Cadia Valley Operations – MOD 14 – Processing Rate Modification

BCS has reviewed the biodiversity development assessment report (BDAR) for the project. The BDAR has not yet demonstrated that the requirements of the Biodiversity Assessment Method (BAM) have been met. BCD's biodiversity recommendations are provided in **Attachment A** and detailed comments are provided in **Attachment B**.

Attachment A – BCS's Recommendations

Attachment B – BCS's Detailed Comments

Figure 1 Examples of native vegetation zones and patch size polygons from Premise shapefiles where patch size may have been incorrectly defined (as highlighted in Table 4 of this response).

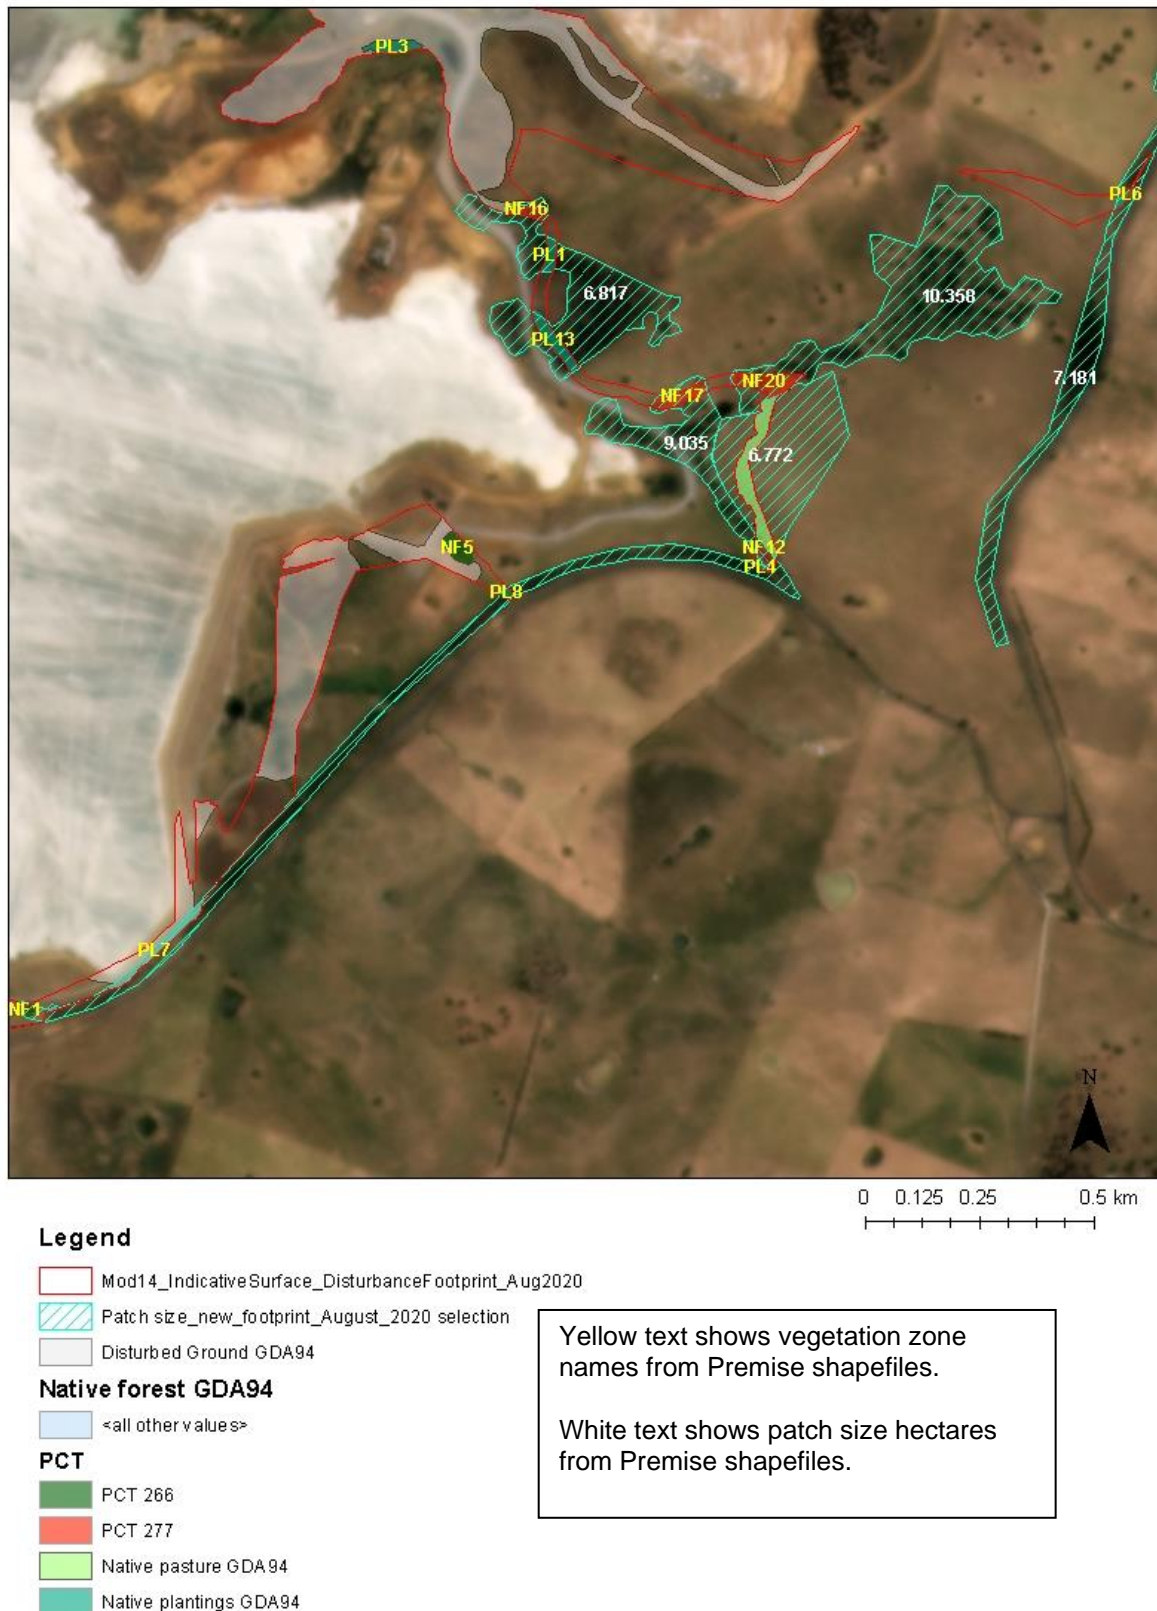
Some specific examples of patch size errors are provided in Table 4 and illustrated in Figure 1 below. These are not necessarily the only errors in patch size allocation.

Zone number in BAM-C	Broad Vegetation Zone Name (BDAR)	Zone sub-name	Issue
7	PCT 277 Moderate	PCT 277 MODNF11_12_17	BAM-C shows patch size category 1 (<5ha) however the patch mapped in the shapefile is 9.04 hectares (ha). A patch of that size would fall into category 2 (5ha to 24ha). However, the shapefile provided indicates that there are four mapped patches of native vegetation that are within 100m of each other and so should be treated as a single patch - 9.04ha, 10.4ha, 6.8ha and 7.2ha. There is also a 6.7ha mapped patch of non-woody native vegetation within 30m. This would take the patch size to 40.14 ha, corresponding to patch size category 3 (25ha to 100ha). See Figure 1 below.
8	PCT 277 Moderate	PCT 277 MODNF20	BAM-C shows patch size category 1 (<5ha) however the patch mapped in the shapefile is 10.4ha. A patch of that size would fall into category 2 (5ha to 24ha). However as for PCT277 MODNF11_12_17 above, there are five mapped patches of native vegetation which should be treated as a single patch falling within patch size category 3 . See Figure 1 below.

10	PCT 277 Moderate	PCT 277 MODNF10	BAM-C shows patch size category 2 (5ha to 24ha) however the patch mapped in the shapefile is 0.03ha. A patch of that size would fall into category 1 .
11	PCT 277 Planting	PCT 277 PL6	Polygon PL6 has been allocated Category 2 in the BAM-C based on a mapped patch of 7.2ha. However as for PCT277 MODNF11_12_17 above, there are five mapped patches of native vegetation which should be treated as a single patch falling within patch size category 3 . See Figure 1 below.
12	PCT 277 Planting	PCT 277 PL1_13	Polygons PL1 and 13 have been allocated Category 2 in the BAM-C based on a mapped patch of 6.8ha. However as for PCT277 MODNF11_12_17 above, there are five mapped patches of native vegetation which should be treated as a single patch falling within patch size category 3 . See Figure 1 below.
17	PCT 277 Plantings	PCT 277 PL4_7_8	BAM-C shows patch size category 1 (<5ha) however the corresponding patch mapped in the shapefile for these polygons is 9.04ha. A patch of that size would fall into category 2 (5ha to 24ha). However as for PCT277 MODNF11_12_17 above, there are five mapped patches of native vegetation which should be treated as a single patch falling within patch size category 3 . See Figure 1 below.

19	PCT 277 derived	PCT 277 Derived	This zone has been allocated Category 2 in the BAM-C based on a mapped patch of 6.8ha. However as for PCT277 MODNF11_12_17 above, there are five mapped patches of native vegetation which should be treated as a single patch falling within patch size category 3 . See Figure 1 below.
23	PCT 277 Moderate	PCT 277 ModNF16	This zone is entered into the BAM-C but is not included in Table 4 of the BDAR. BAM-C shows patch size category 1 (<5ha) however the patch mapped in the shapefile is 6.82ha. A patch of that size would fall into category 2 .

8.1 The assessor should:

- a) check all patch size mapping against the requirements of BAM
- b) check all patch size data entered into the BAM-C

then update the BDAR and BAM-C case as necessary.
